# 303 MARINE DRIVE - 28 MAY 2018

# ISSUES FOR RECONSIDERATION

# MARKET - SMALLER HOUSING OPTIONS

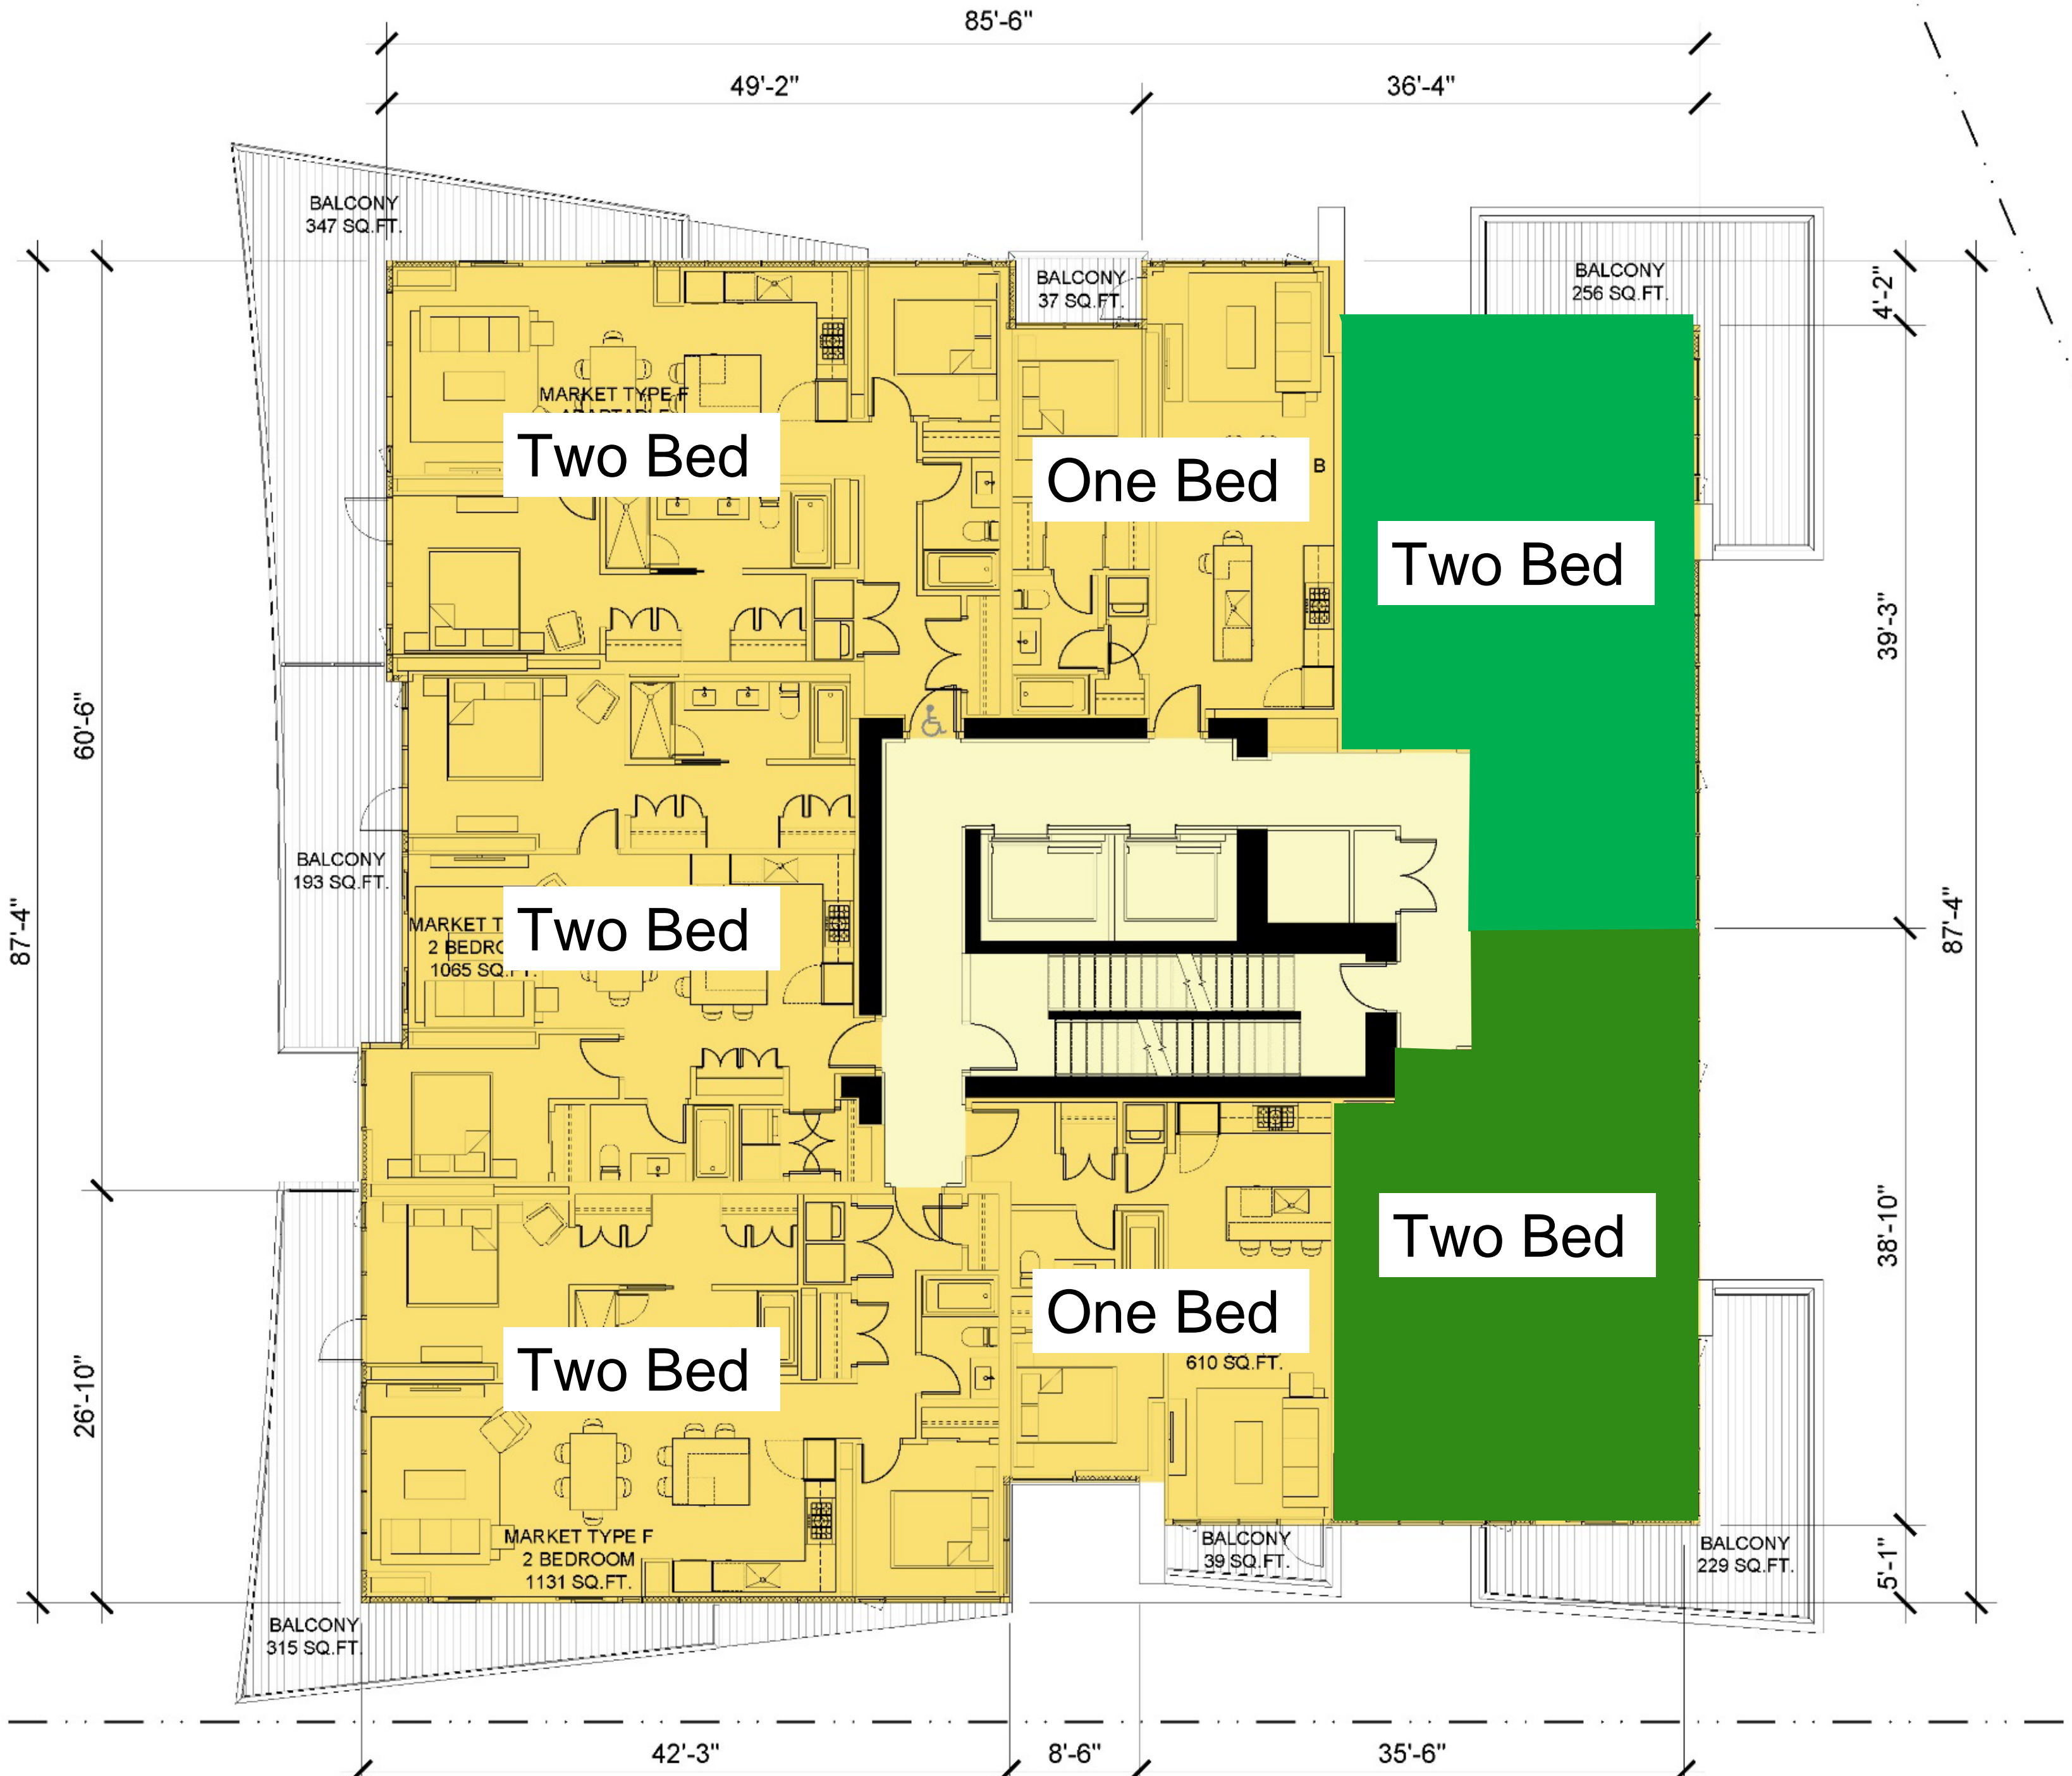
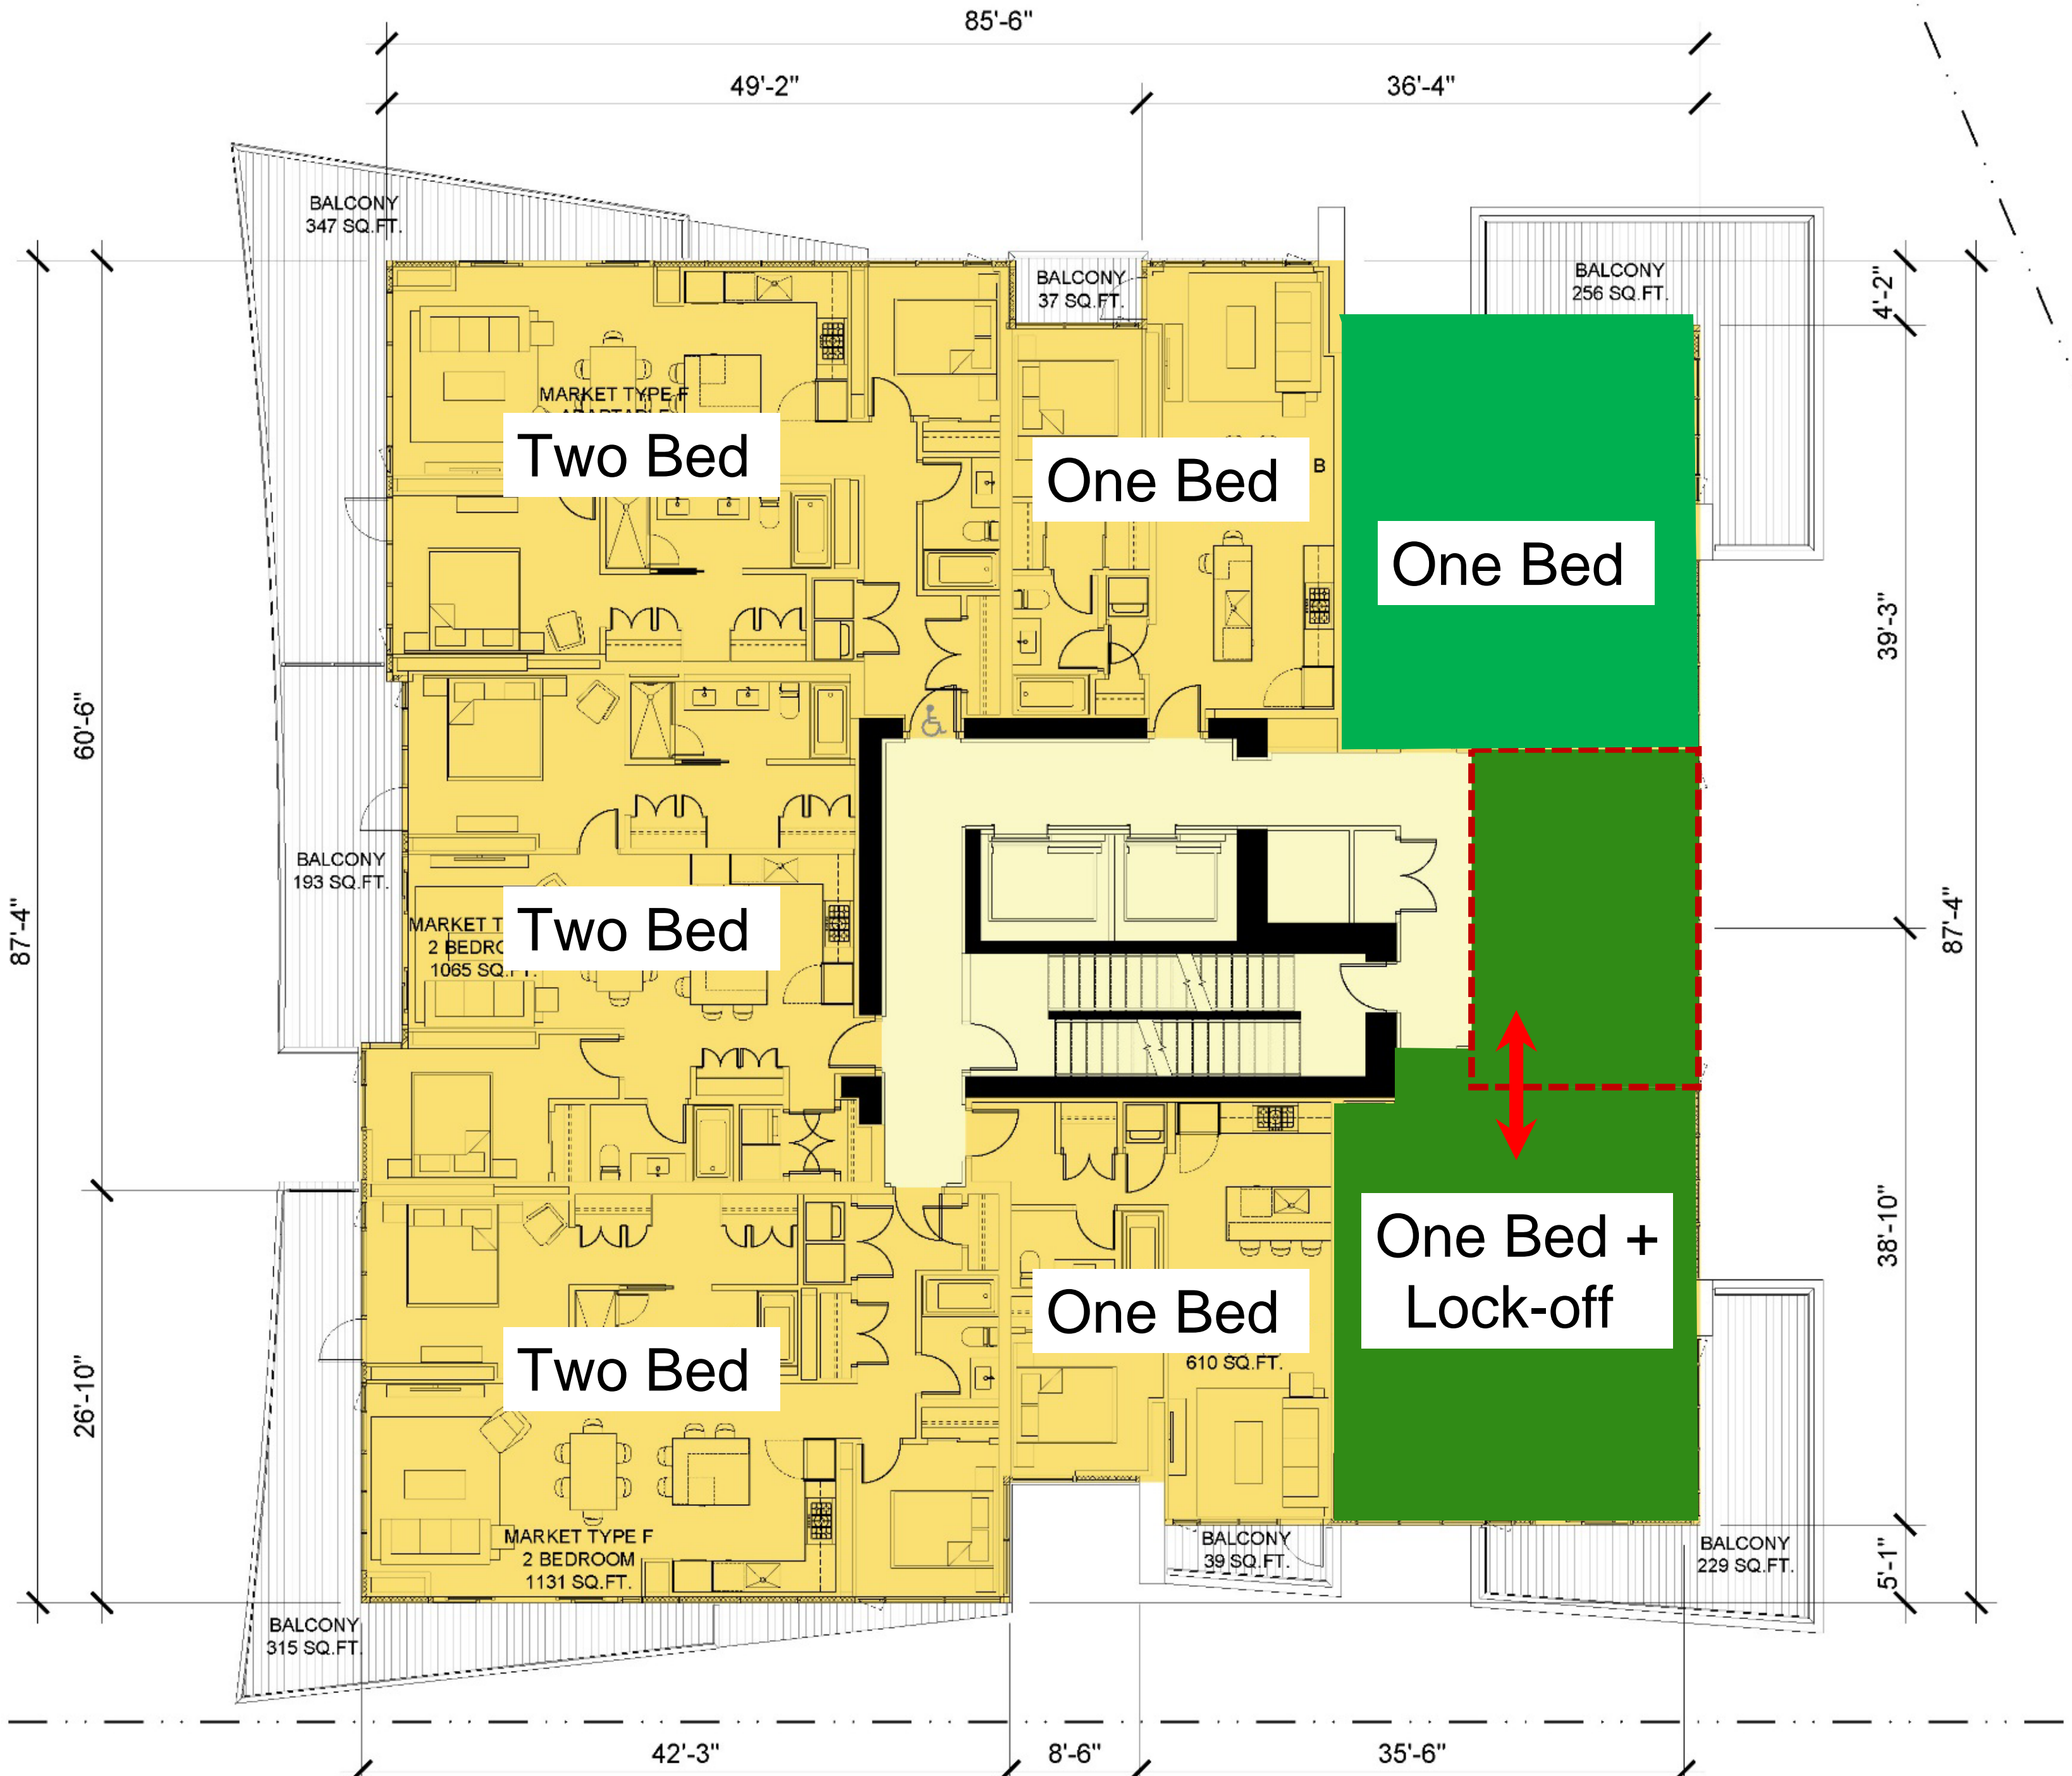
## BEFORE

Studio	N/A	0	(0%)
1 Bed	600 sf	8	(9%)
1+ / Jnr 2 Bed	820 sf	8	(9%)
2 Bedroom +	1,100 sf	71	(78%)
Townhouse	1,500 sf	4	(4%)

## AFTER

1+lock-off	760+300 sf	4	(5%)
1 Bed	600 sf	12	(14%)
1+ / Jnr 2 Bed	820 sf	0	(0%)
2 Bedroom +	1,100 sf	71	(82%)
Townhouse	N/A	0	(0%)
